O.P.W Ref No. 379-2024

Re: SID Planning Application No. 323780, The Proposed Windfarm within the townlands of Ballincurra, Ballinlee South, Ballinqayroure, Ballinbea, Knockuregare, Balinlee North, Carrigeen and Camas South, Bruff, Co. Limerick

Case Reference ACP PAX91.323780
Administrative Officer
Strategic Infrastructure Development Section,
An Coimisiún Pleanála,
64-67 Marlborough Street,
Dublin 1
D01 V90

ACP- PAX91.323780: Proposed Wind Farm Development in the townlands of Ballincurra, Ballingayrou, Ballinlee North & South, Ballinrea, Ballyreesode, Camas North & South, Carrigeen, Knockuregare, Ballybane and other townlands in County Limerick

Fig. 1 Extract from the Limerick County Development Plan 2022-2028 mapping Views and Prospects

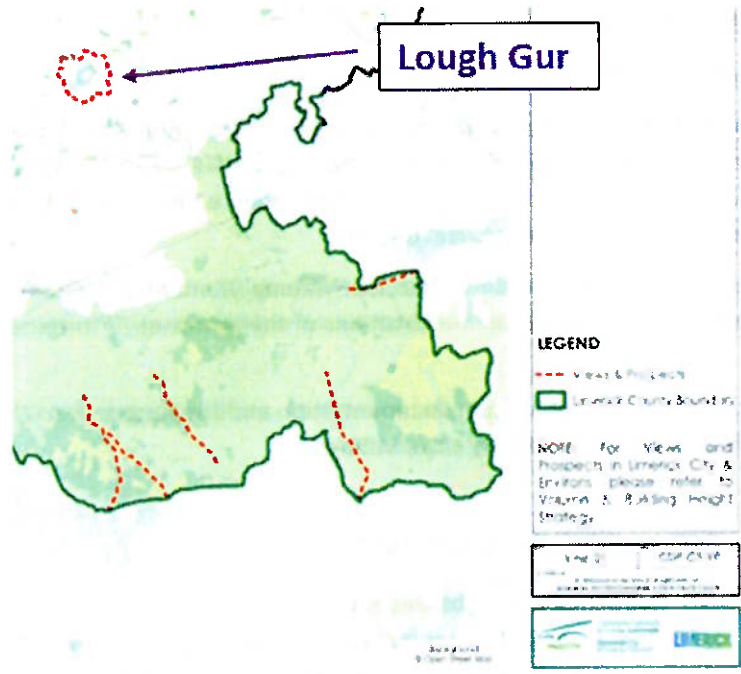
Lough Gur is identified in the *Limerick County Development Plan 2022-2028* for protection of Views and Prospects (see Fig 1 below).

Fig. 3 Extract from ZTV mapping for cumulative impact, with Lough Gur and Knockainey highlighted by the OPW

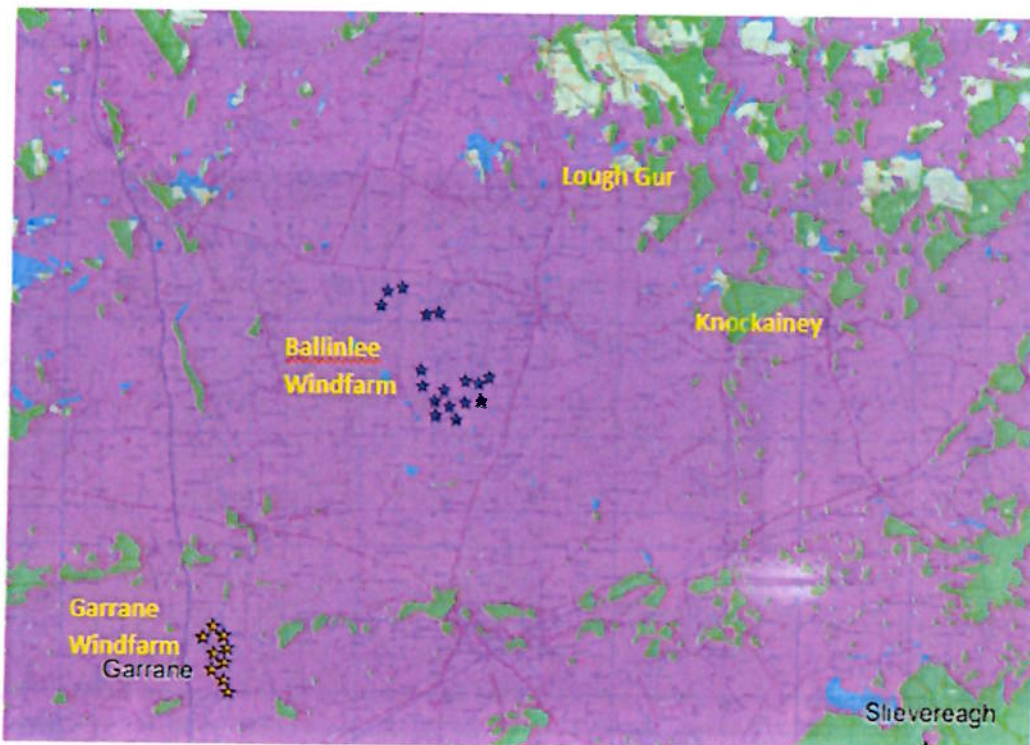
The OPW is including here an extract from photomontage (VP21) which formed part of the planning documentation for ACP case reference: PAX91.323635 Garrane Windfarm Co.Limerick, Garrane Windfarm (ACP undecided) is located 17km to the southwest of Lough Gur. The proposed Ballinlee windfarm will be located in the foreground around 5km or less from Lough Gur (see Fig. 3 below).

The OPW is very concerned about the visual and cultural impact of the proposed Ballinlee Windfarm from this view and the cumulative impact with Garrane windfarm. The OPW urges ACP to require the application to produce a photomontage from this location, for Ballinlee WF alone and as a cumulative impact assessment.

Fig. 4 Aerial photograph showing relative locations of the proposed windfarm and high significance heritage locations: Lough Gur, Knockainey and Emlý

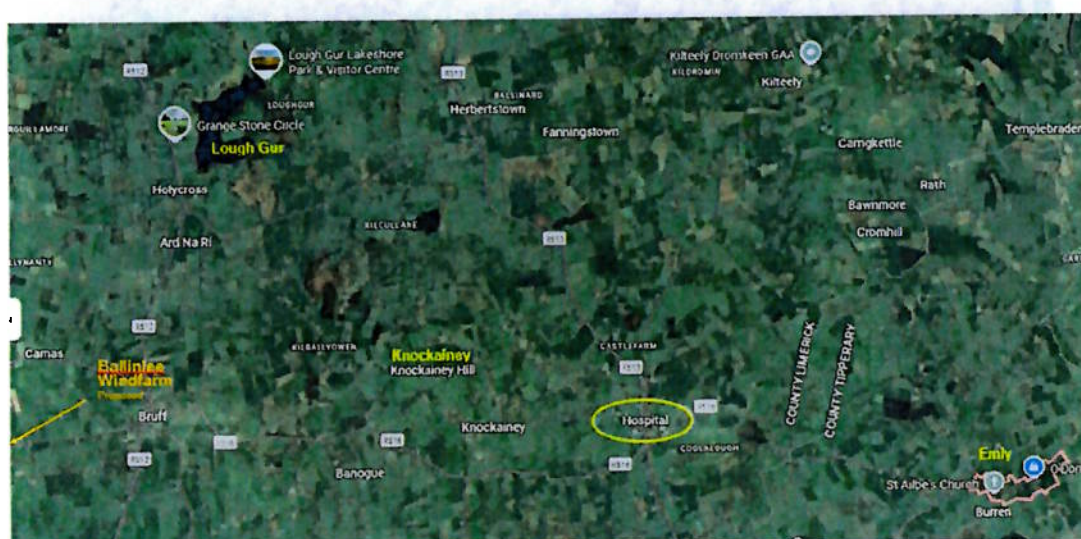
The connections include the pre-Christian sun goddess Áine preserved in the placename of Knockainey and integrated into the intangible cultural heritage of the Lough Gur cultural landscape. Due to the historical connections and the landscape/setting value of Knockainey Hill in relation to Lough Gur, the OPW requests that ACP require that a visual and/or cultural impact assessment is undertaken from appropriate vantage points on Knockainey Hill, underpinned by verifiable photomontage and visual impact analysis, including cumulative impact.

The applicants should provide a description of this cultural landscape and an assessment of the potential impact and cumulative impact of Ballinlee and Garrane windfarms, including their transmission infrastructure.
